**WIDOWS CREEK FOSSIL PLANT
ANNUAL ASH POND DIKE STABILITY INSPECTION
FY 2009**

The waste disposal areas at Widows Creek Fossil Plant (WCF) were inspected for dike structural stability on October 15 and 16, 2008 by Kelly Evans of TVA Fossil Engineering Design Services (EDS) and Jamie Dotson of TVA Fuel By-products. The previous annual inspection was performed on December 5 and 6, 2007. The results of the inspection of the Coal Yard Drainage Basin, Coal Yard Perimeter Ditch, Limestone Pile Drainage Basin, Wet Gypsum Stacking Area, Stilling Pond for the Wet Gypsum Stacking Area, Active Ash Pond, Stilling Pond for Active Ash Pond, Dredge Cell, Perimeter Dikes, Red Water Pond, Chemical Treatment Pond, and the Abandoned Ash Disposal Area are listed below. A summary of recommendations is also provided. Estimated costs are based on the 2009 RSMEANS Building Construction Cost Data (quotes are advised for more accurate estimate).

Figure 1. Measured Weir Outflow vs Design and Plant Rating Curves
Based on Dye-Dilution Tests of May 16, 1995

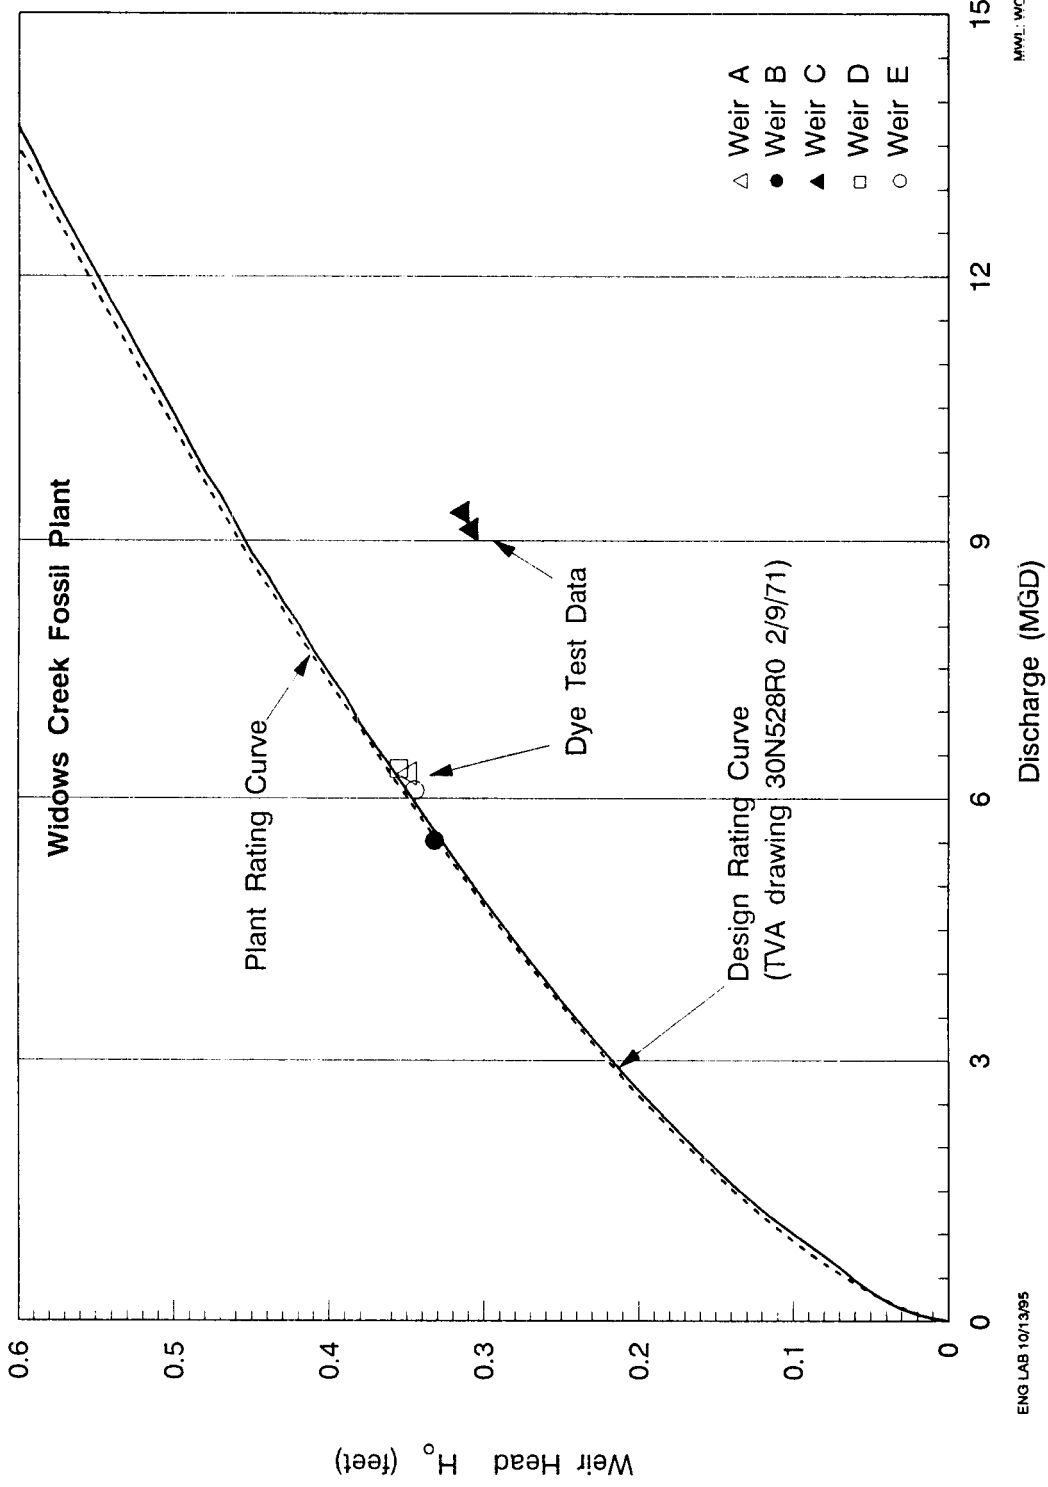
Test results for each weir are given in Table 1. Based on data recorded in the dye-dilution technique, the measured flowrates obtained in these tests are estimated to be within ± 3 percent of the true flowrates. In Figure 1, the average measured flowrates are compared with the design rating curve from TVA drawing 30N528 R0, dated 2/9/71, and the rating curve currently used by the plant. In Table 2, the error in flowrate for the design and plant rating curves is provided for each weir. The error is computed as the difference between the flowrate found by the design and plant curves, based on the measured head, and the flowrate measured by the dye-dilution technique. The following comments are provided.

Figure 2. Ash Pond Weir Outflow and Leakage Flow Based on Dye-Dilution Tests of May 16, 1995

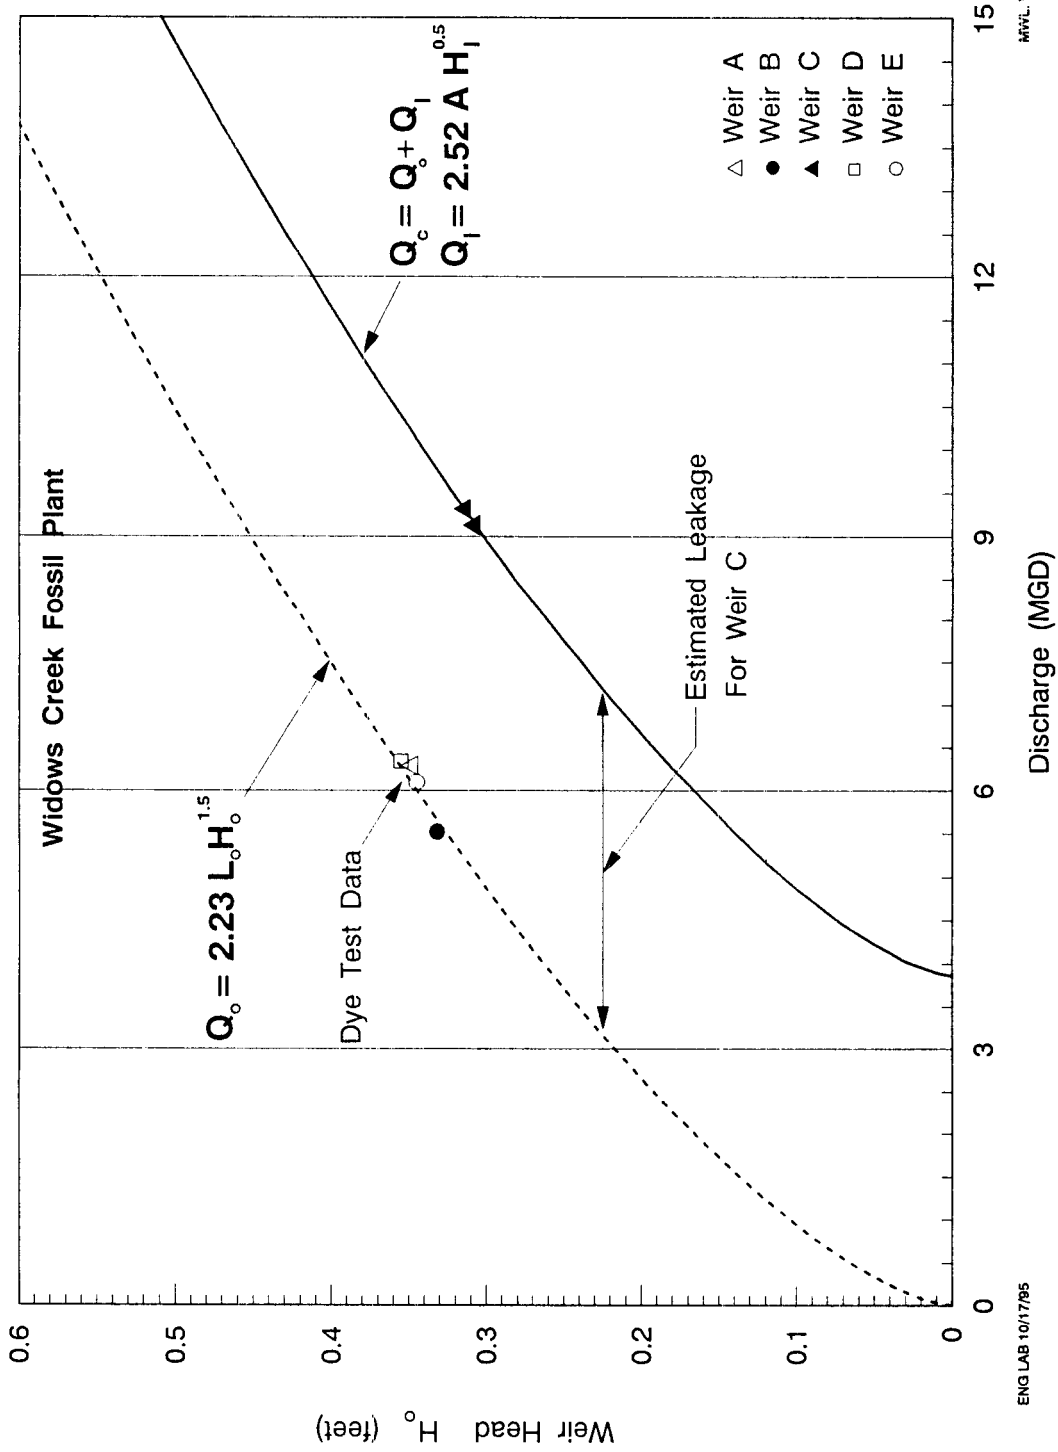
A comparison between the computed and measured flowrates is given in Figure 2. The computed flowrate for all weirs, expressed as a function of water surface elevation, is given in Table 5 (i.e., $Q_A + Q_B + Q_C + Q_D + Q_E$). In computing the values for Table 5 it should be noted that for a given water surface elevation, the head will be different for each weir depending on the elevation of the weir crest.
